PROSPERITY CHURCH ROAD SITE  
PROPOSED REZONING FOR  
THE MCALPINE CO., INC.  
6725-D FAIRVIEW ROAD  
CHARLOTTE, NORTH CAROLINA 28210

FOR PUBLIC HEARING  
PETITION # 2000-78  
TECHNICAL  
PLAN

CHARLOTTE-MECKLENBURG  
PLANNING COMMISSION  
INTER-OFFICE COMMUNICATION

SUBJECT: Administrative Approval for Petition No. 2000-78 by Francis C. Mizelle.

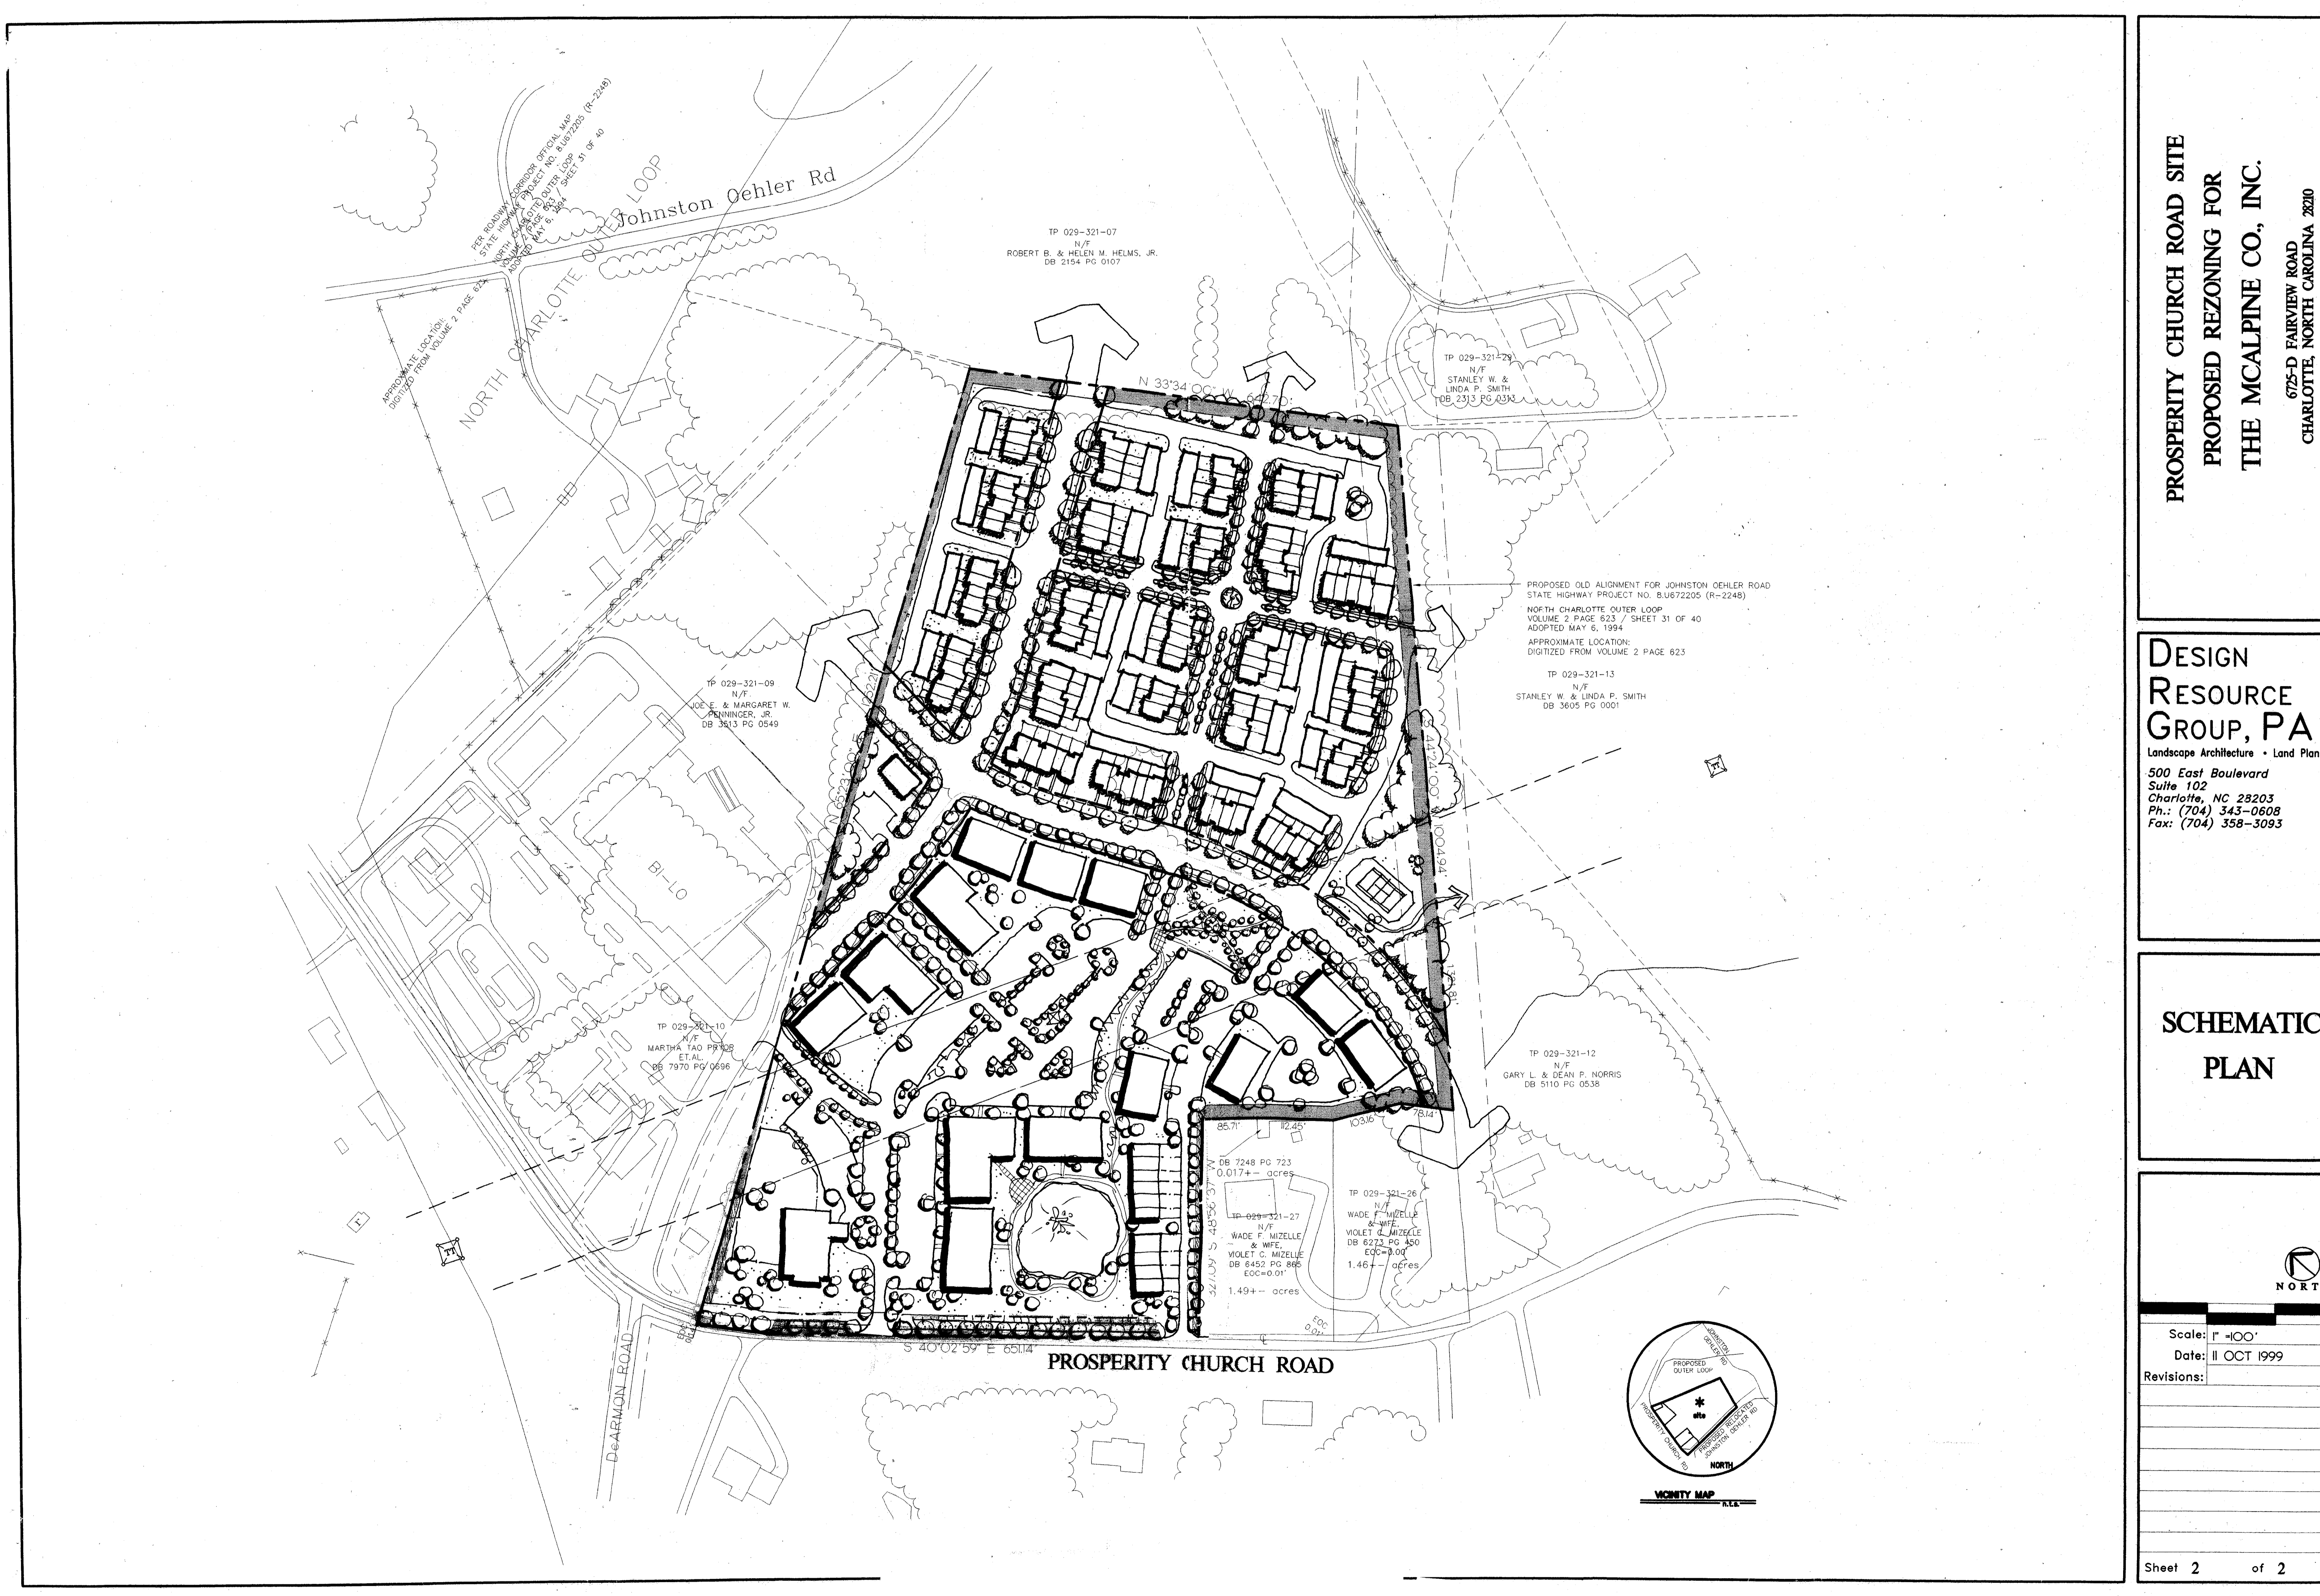
Attached is a revised plan for the above referenced petition. The plan has been revised to allow 193 dwelling units on 16.14 acres (area A). The acreage increased slightly because the amount of right-of-way required was reduced. Since this change is minor, I am administratively approving this increase in the number of units. Please use this revised plan when evaluating requests for building permits and certificates of occupancy.

- AREA A: 16.14 ACRES (806 ACRES) 193 UNITS ALLOWED AT 12 D.U./A
- AREA B: 8.06 ACRES (65,000 SF. OFFICE ALLOWED 12,000 SF. DAY CARE ALLOWED)
- AREA C: 1.13 ACRES (3,000 SF. RETAIL ALLOWED)

FOR PUBLIC HEARING  
PETITION # 2000-78  
TECHNICAL  
PLAN

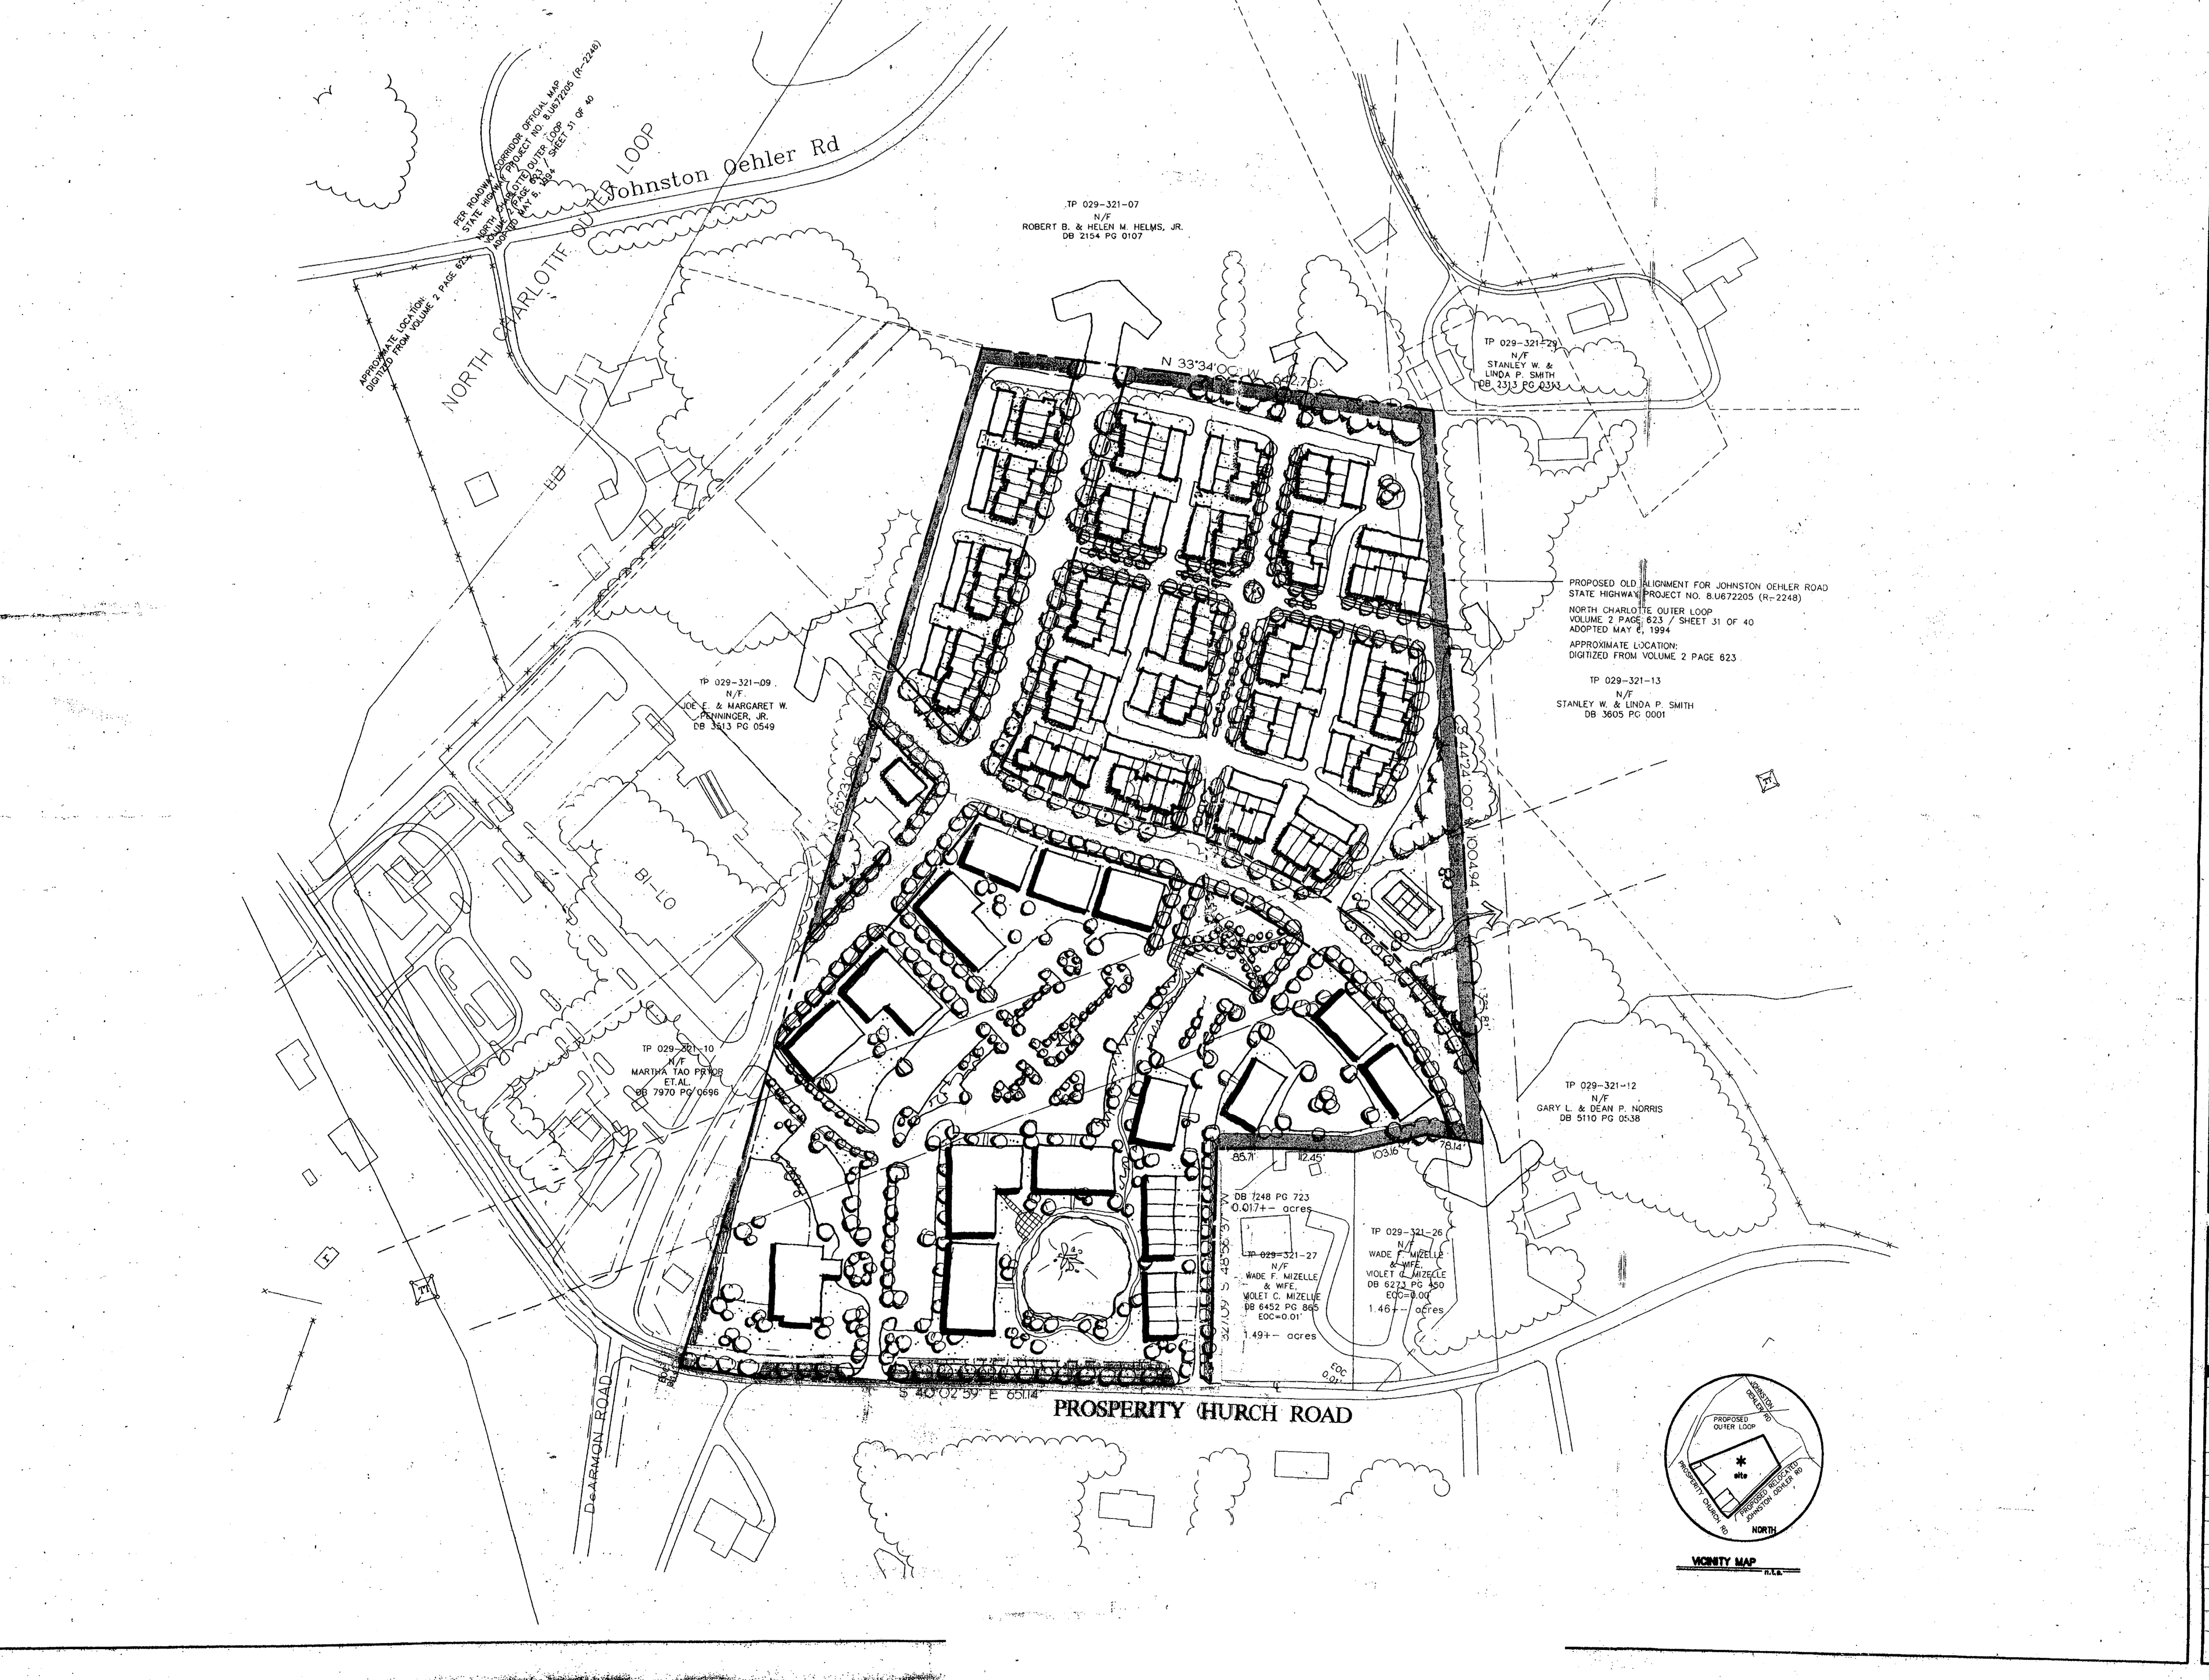
Attached are revised plans and building elevations for the above referenced petition. The plans have been revised to allow the building facades to be predominantly brick, or stone and to incorporate building elevations for buildings that will be retrofitted to meet this requirement. Since these changes are minor, I am administratively approving these plans and building elevations. Please use these revised plans and building elevations when evaluating requests for building permits and certificates of occupancy.
